**MODIFICATION REQUEST:
Mixed Residential and Retail Development
21 – 35 Treacy Street, Hurstville
Earljest Pty Ltd**

Modification MP10_0101 MOD 2

Director-General's
Environmental Assessment Report
Section 75W of the
Environmental Planning and Assessment Act 1979

April 2014

Figure 2: Tracy Street elevation showing proposed increase in height

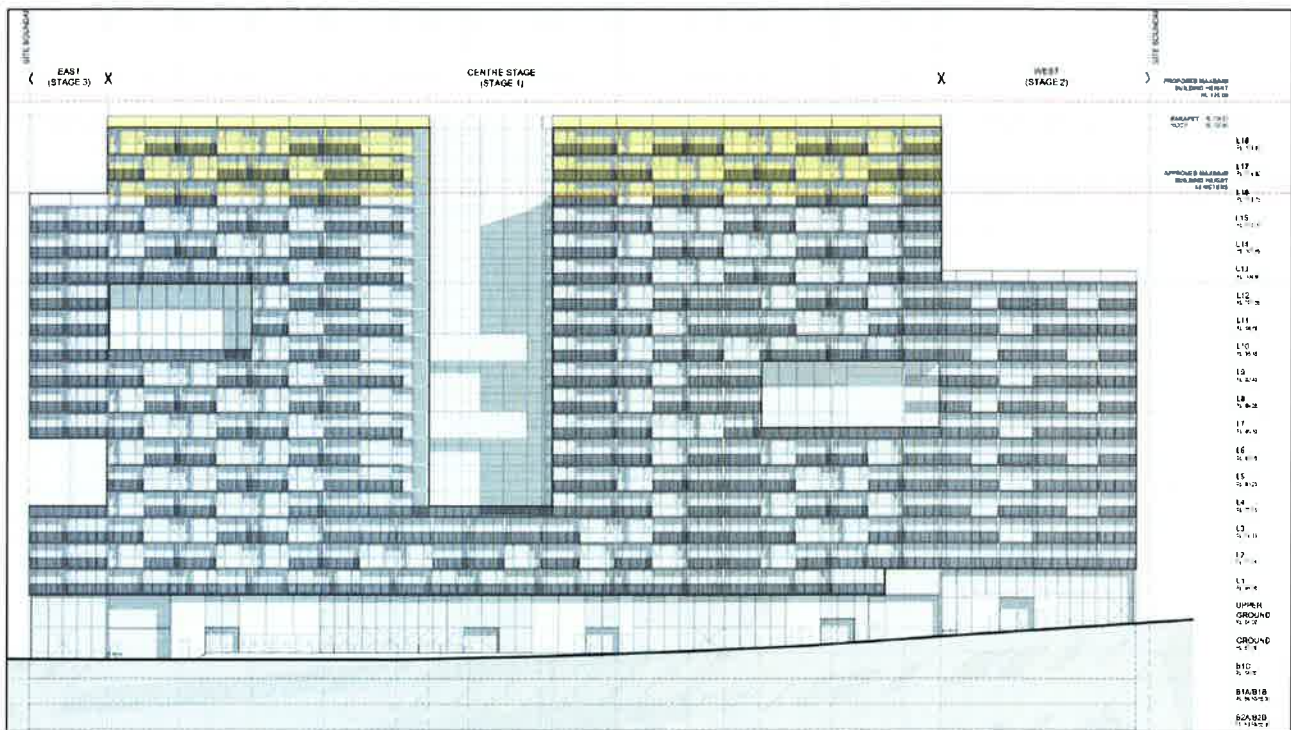
The proposed additional 3 levels are depicted in **Figures 2 to 4** below.

The proposed modification seeks an increase in the building envelope height by 3 storeys (from 16 to 19 storeys) or by 11.4 metres (from maximum height of 55 metres (RL 114.6 AHD) to maximum height of 66.4m (RL 126.0 AHD). It also seeks to increase maximum gross floor area from 28,474m² to 32,497m², resulting in a change in floor space ratio (FSR) from 6.78:1 to 7.74:1.

Figure 7: Perspective drawing of the proposal in context looking north (source: Proponent's EA)

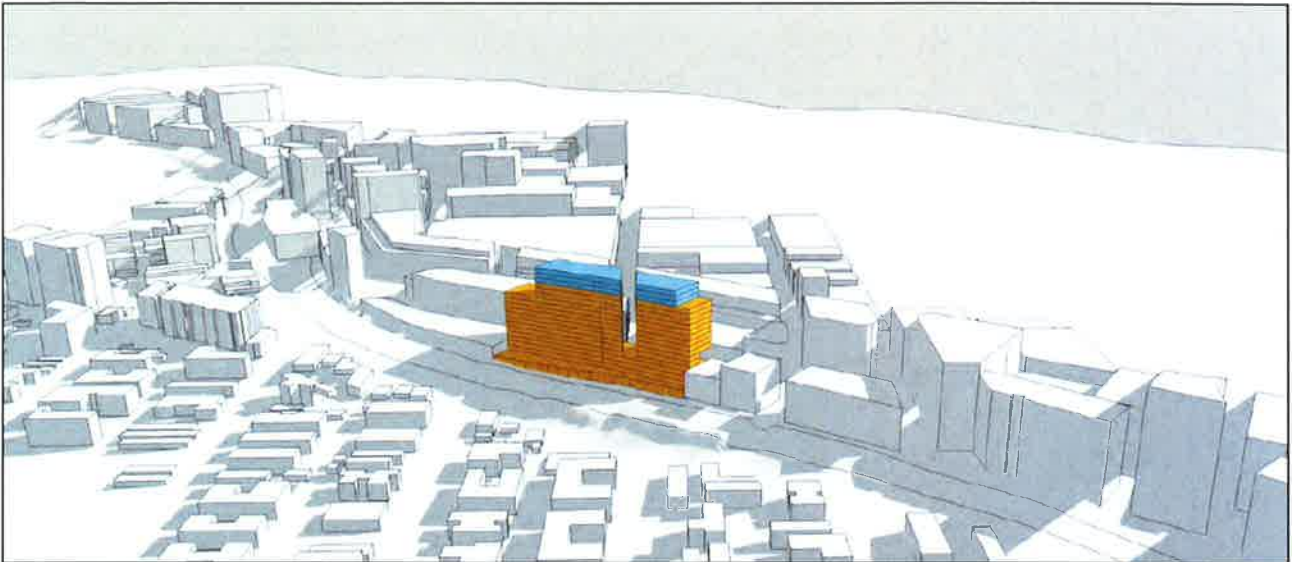
In terms of context and visual impacts, consideration has been given to the existing and emerging skyline of Hurstville. To demonstrate the merits of the proposed height in the context of the surrounding built forms, the proponent has submitted comparative east-west and north-south height studies, taking into account likely future development in accordance with Council's height controls as well as recently approved and existing developments. The height study images detail the location and form of the proposed development within the Hurstville city centre skyline. Refer to **Figures 5** and **6**. The proponent has also submitted numerous perspective drawings and photomontages to demonstrate the visual impact of the proposed additional 3 storeys in the context of surrounding development. Refer to **Figures 7 - 10**.

The contextual analysis demonstrates that while the proposed modifications would result in the building being one of the tallest developments within the city centre, it would still fall within the broad spectrum of building heights visible within the skyline and would not appear out of context in that regard.

The agency therefore considers the proposed height and scale to be appropriate in terms of its context, visual impacts and strategic planning objectives.

Figure 11: Shadows at 1pm mid-winter (source Proponent's EA)

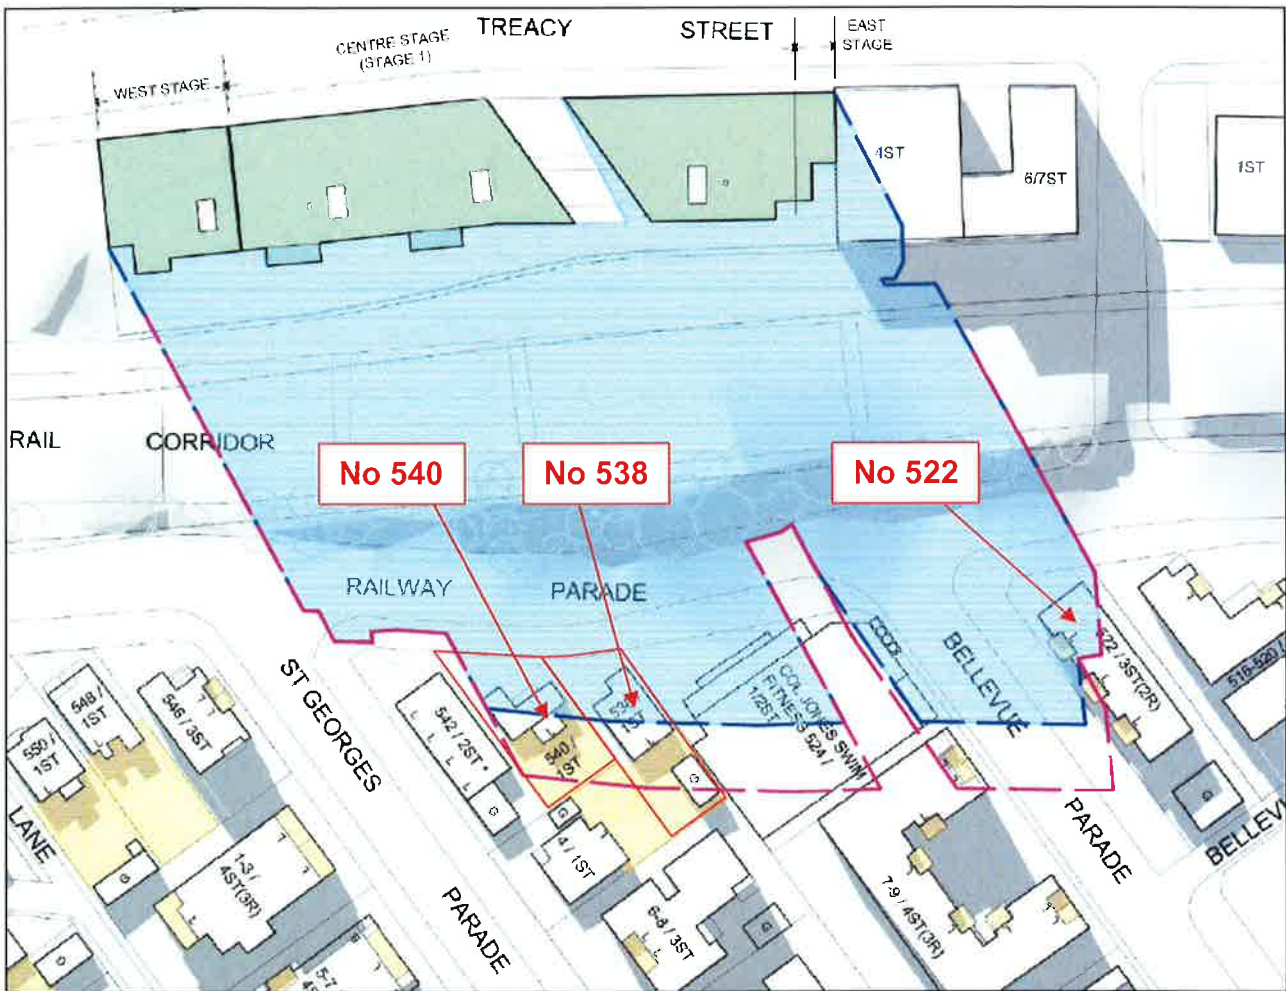
- Additional overshadowing to rear gardens of dwellings at Nos 538 and Nos 540; and
- Additional overshadowing to balconies and living room windows of units at 522 Railway Parade.

The development as already approved will partially shadow the south-west façade between 2.00pm and 3.00pm and the proposed modification will result in some additional shadowing such that some living room windows and balconies will receive no sunlight and others receiving only a few minutes at mid-winter.

In relation to 522 Railway Parade, the agency considers that although the living rooms and balconies would have a further reduction to already very limited solar access under the modification, the amount of sunlight lost compared to the approved development is not extensive (around 10-30 minutes at mid-winter for each of the balconies). If existing shadowing from the trees were taken into account, the impacts would be even more marginal. More importantly however, the agency notes that the affected apartments are all cross-through apartments and all incorporate large windows on the north-eastern façade providing good levels of solar access to the adjoining bedrooms and kitchens. These windows are the main source of sunlight to the dwellings and the solar access to these windows will not be diminished by the proposed modification. The overall quality of sunlight to the dwellings is therefore not considered to be substantially reduced by the proposed modification.

Figure 14: Extent of modification that would need to be deleted.

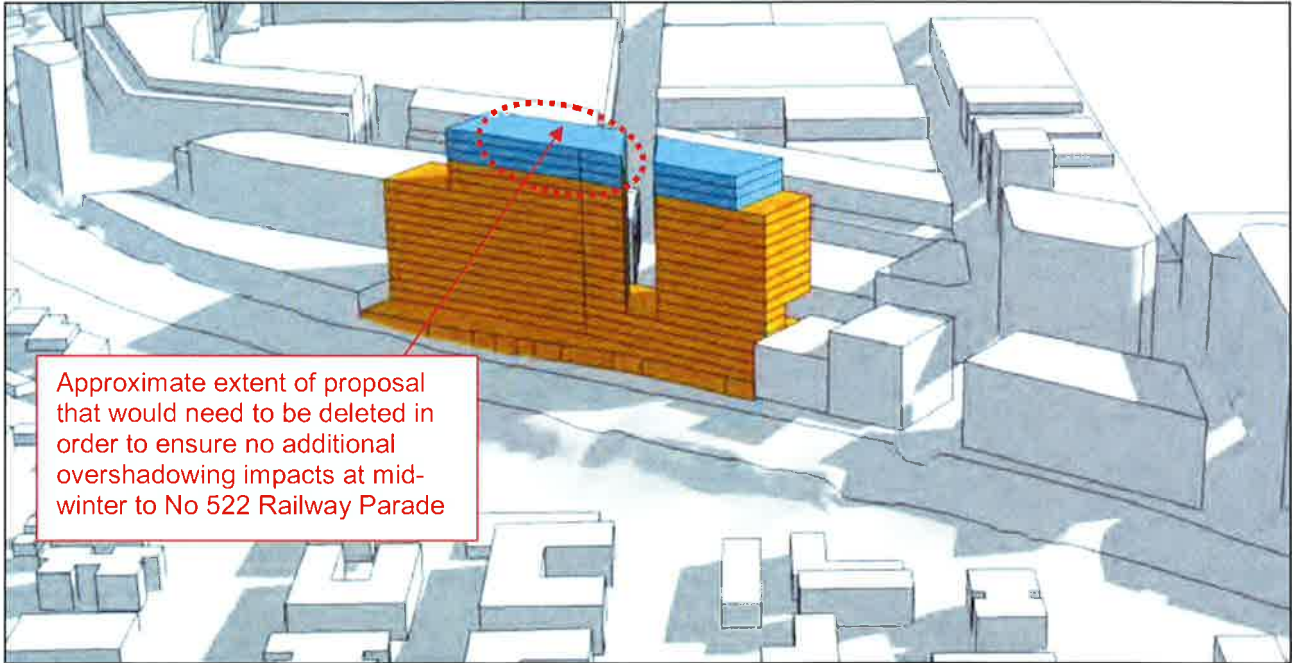
The agency considered whether amendments could be made to reduce impacts to the dwellings at No 522. It was found that in order to ensure the proposal resulted in no additional impacts at mid-winter, virtually all of the western section of the additions would need to be deleted (refer **Figure 14**). This equates to more than half of the proposed additional floor space (or 27 apartments) and would result in an inferior design and awkward appearance to the building as well as a reduced development potential.

Having regard to all of the above issues, the extent of the overshadowing impacts is considered to be acceptable. The impacts are considered to be relatively minor, affecting a limited number of dwellings for short timeframes. Affected gardens will still receive reasonable amounts of sunlight to provide amenity for the occupants. The dwellings that will lose sunlight to living rooms and balconies will still receive solar access to other rooms, thereby ensuring a reasonable level of amenity despite the vulnerability of the sites arising from their location and orientation. On balance, the overshadowing impacts are considered to be minor, and when considered in light of the strategic planning objectives of increased residential densities close to services and public transport in an area characterised by high density development, are well justified and as such the modification is supported.

Figure 16: Stage 1 ground floor as proposed

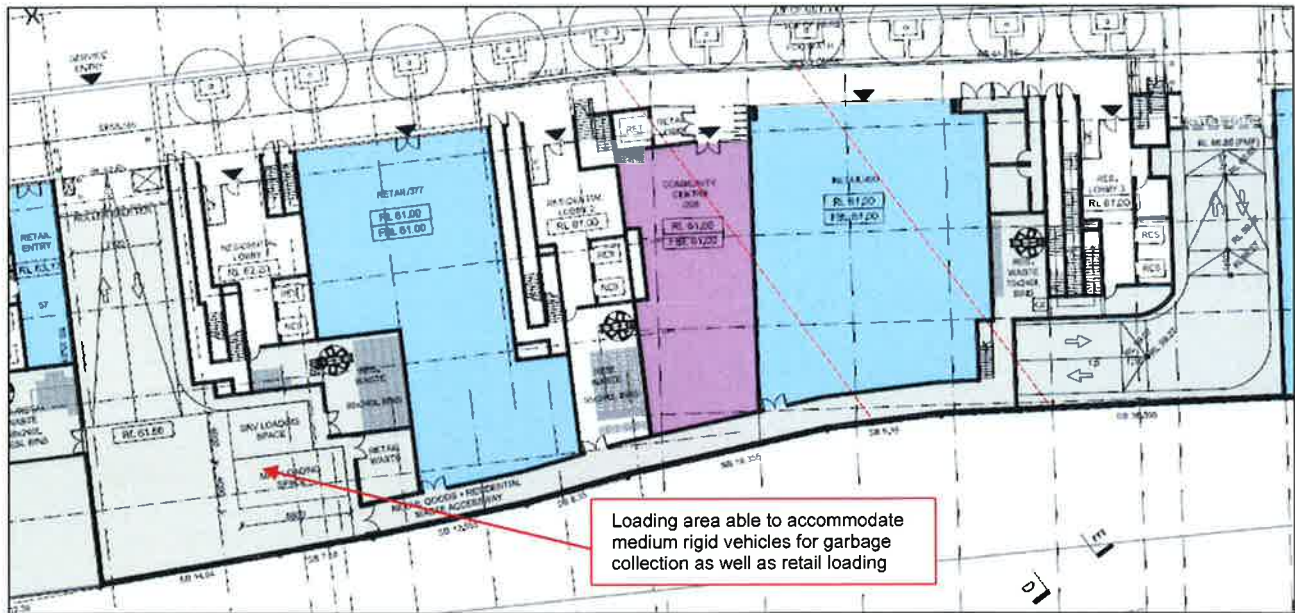
The provision of a mezzanine for 20 parking spaces is considered to be unnecessary as the indicative plans include an oversupply of parking (in the order of 97 spaces) as discussed above in **Section 5.3**. It is also contrary to accepted urban design principles and the local controls in Hurstville DCP 2 which require that parking be provided at basement levels.

In addition, the proposed mezzanine level results in reduced floor to ceiling heights for part of the ground floor level below, resulting in reduced amenity and being contrary to the Residential Flat Design Code which recommends minimum floor to ceiling heights of 3.3 metres at the ground and first floor levels in mixed use buildings.

The provision of the vehicle access ramp to the mezzanine level also results in the deletion of the vehicle access previously proposed to the ground floor level and deletion of the associated loading docks and on-site waste collection areas, such that waste would now need to be taken to the street for collection (refer **Figures 15 and 16**). It is considered essential for the amenity of the locality that waste collection be carried out entirely within the building envelope. It is also considered essential that adequate loading facilities be provided in order to support the use of the ground floor

These matters can be resolved at the detailed design phase as part of future development applications. A future environmental assessment requirement is therefore recommended that future applications be accompanied by amended floor plans which are demonstrated to maximise ground floor street activation, delete mezzanine car parking, provide adequate on-site loading bays to service all non-commercial uses and residential waste collection entirely within the building envelope, and investigate the potential to provide such loading areas at the basement level.
